Points of difference between AD4401-05 and AD4401-06

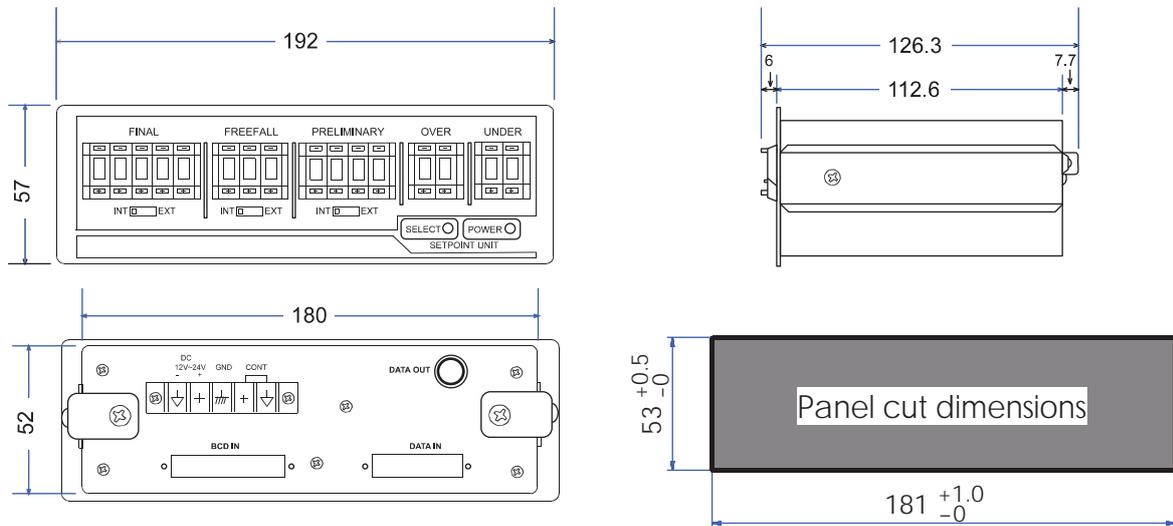
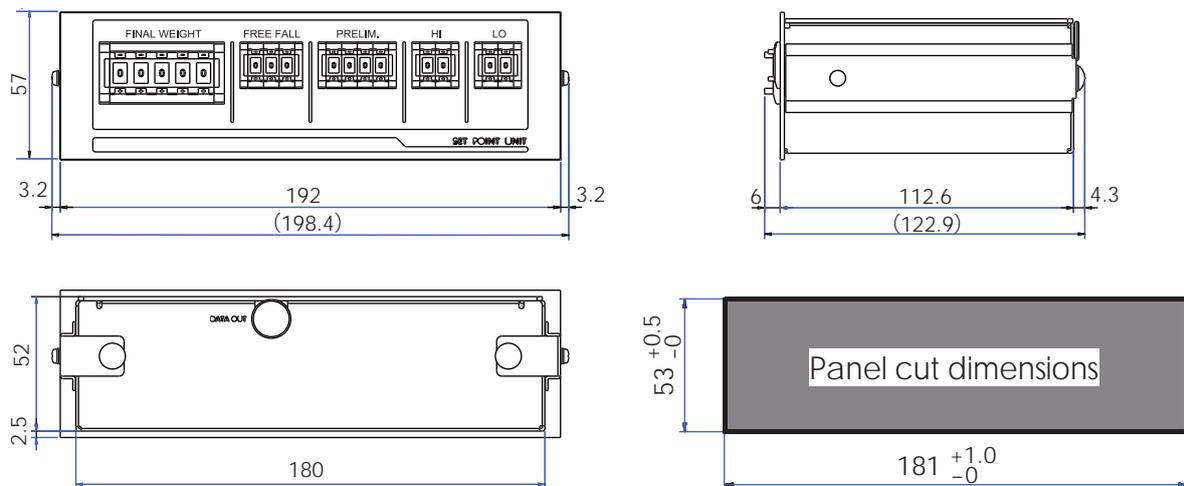
1. The dimensions of OP-05 and OP-06 are almost identical, while the panel cut dimensions are exactly the same. It is possible to easily shuffle between OP-05 and OP-06 installed on the instrumentation board.
2. Setting values can be set externally for OP-05 in BCD, but not for OP-06.
3. For the AD4401, several OP-05 units can be serially connected, however only one unit of the OP-06 can be connected.
4. When OP-05 is receiving BCD input from an external source and several units are connected, an external power supply is required, but this is not the case for OP-06 or when only one OP-05 unit is connected.
